Contract #: 04-0120F4Cty: SF/ALA Rte: 80 PM: 13.2/13.9File #: 69.25B**QUALITY ASSURANCE -- NON-CONFORMANCE REPORT****Location:** Changxing Island, Shanghai, PRC**Report No:** NCR-000171**Prime Contractor:** American Bridge/Fluor Enterprises, a JV**Date:** 03-Jul-2008**Submitting Contractor:** Zhenhua Port Machinery Company, Ltd (ZPMC), Changxing Island**NCR #:** ZPMC-0155**Type of problem:**

**Reference Description:** Unapproved base metal repair EP-17B, 5B**Description of Non-Conformance:**

**Job Name:** SAS Superstructure

**Subject:** NCR No. ZPMC-0155

项目名称 Project Name	美国海湾大桥 SFOBB	部件图号 Drawing No	EP5	报告编号 Report No.	B-WR641
合同号 Contract No.:	04-0120F4	部件名称 Items Name	腹板EP5B Edge Plate	NDT报告编号 Report No.of NDT	
项目编号 Project No.:	ZP06-787

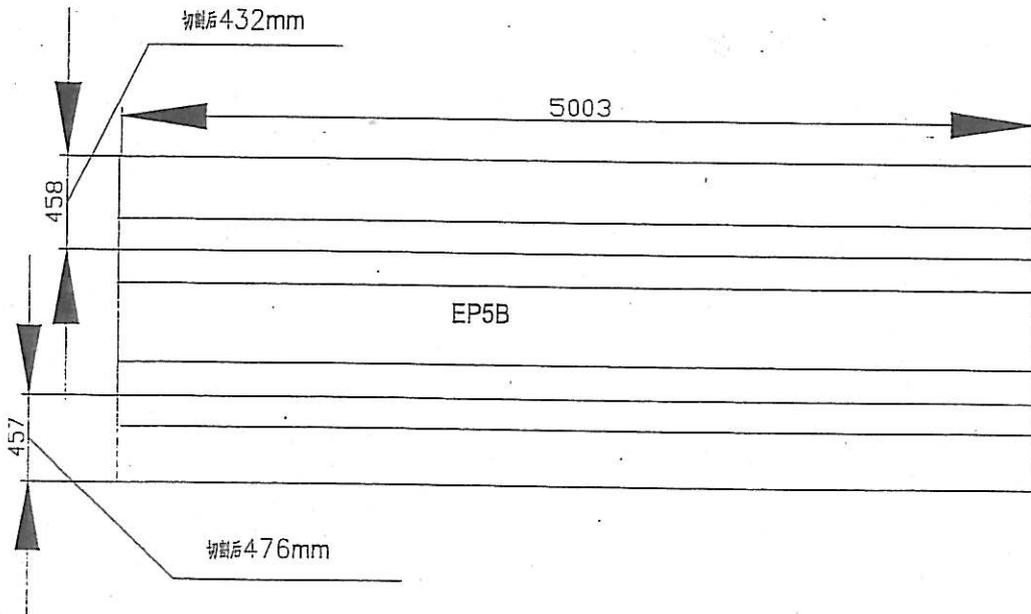
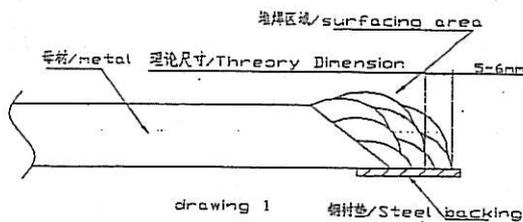
胡国兴施工队在切割3A-E角单元板EP5B一边余量时割短16mm, 具体见下图:

The EP5B of 3A-E corner section was cut more 16mm by Work Team: Hu Guoxing; the follo wing shows the detail position.

由于ACL线洋冲眼敲打有误差, 导致以洋冲眼为基准点划线切割余量后短16mm。

There is some error during fixing on ACL causing the cutting line offset 16mm.

1. 对需要修补的区域进行VT与MT检测;
2. 按照图一所示加钢衬垫;
3. 根据返修的焊接返修工艺规程(WPS)进行预热及焊接, 焊后尺寸要比实际尺寸大5-6mm;
4. 去除钢衬垫, 将修补焊缝打磨至与周围母材平齐;
5. 对返修区域做NDT (VT MT UT) 以保证金属融合的深度;
6. 按照图纸要求重新进行切割。

1. Verify with VT and MT repair area is free of all defects.
2. Add ceramic backing according to the attached drawing 1;
3. Preheat and weld according to the relevant WPS and dimension of lineament is more than 5-6mm necessary actual dimension;
4. Remove the ceramic backing and grind the weld flush with around metal;
5. Perform post NDT (VT MT UT) of repaired area to insure sound weld metal has been deposited.
6. Prepare cutting again according to the shop drawings

项目名称 Project Name	美国海湾大桥 SFOBB	部件图号 Drawing No	EP20	报告编号 Report No.	B-WR642
合同号 Contract No.:	04-0120F4	部件名称 Items Name	腹板EP20A Edge Plate	NDT报告编号 Report No.of NDT	
项目编号 Project No.:	ZP06-787

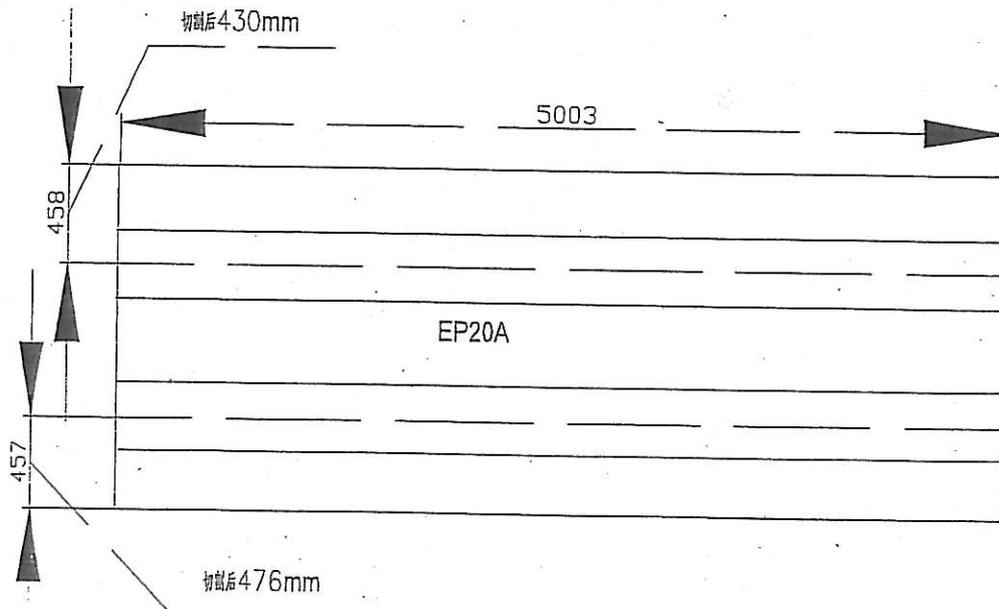
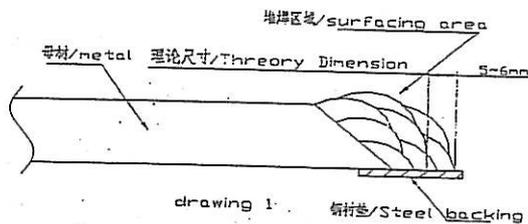
胡国兴施工队在切割4B-E角单元板EP20A一边余量时割短18mm, 具体见下图:

The EP20A of 4B-E corner section was cut more 18mm by Work Team: Hu Guoxing; the following shows the detail position.

由于ACL线洋冲眼敲打有误差, 导致以洋冲眼为基准点划线切割余量后短18mm。

There is some error during fixing on ACL causing the cutting line offset 18mm.

1. 对需要修补的区域进行VT与MT检测;
2. 按照图一所示加钢衬垫;
3. 根据返修的焊接返修工艺规程(WPS)进行预热及焊接, 焊后尺寸要比实际尺寸大5-6mm;
4. 去除钢衬垫, 将修补焊缝打磨至与周围母材平齐;
5. 对返修区域做NDT(VT MT UT)以保证金属融合的深度;
6. 按照图纸要求重新进行切割。

1. Verify with VT and MT repair area is free of all defects.
2. Add ceramic backing according to the attached drawing 1;
3. Preheat and weld according to the relevant WPS and dimension of lineament is more than 5-6mm necessary actual dimension;
4. Remove the ceramic backing and grind the weld flush with around metal;
5. Perform post NDT (VT MT UT) of repaired area to insure sound weld metal has been deposited.
6. Prepare cutting again according to the shop drawings
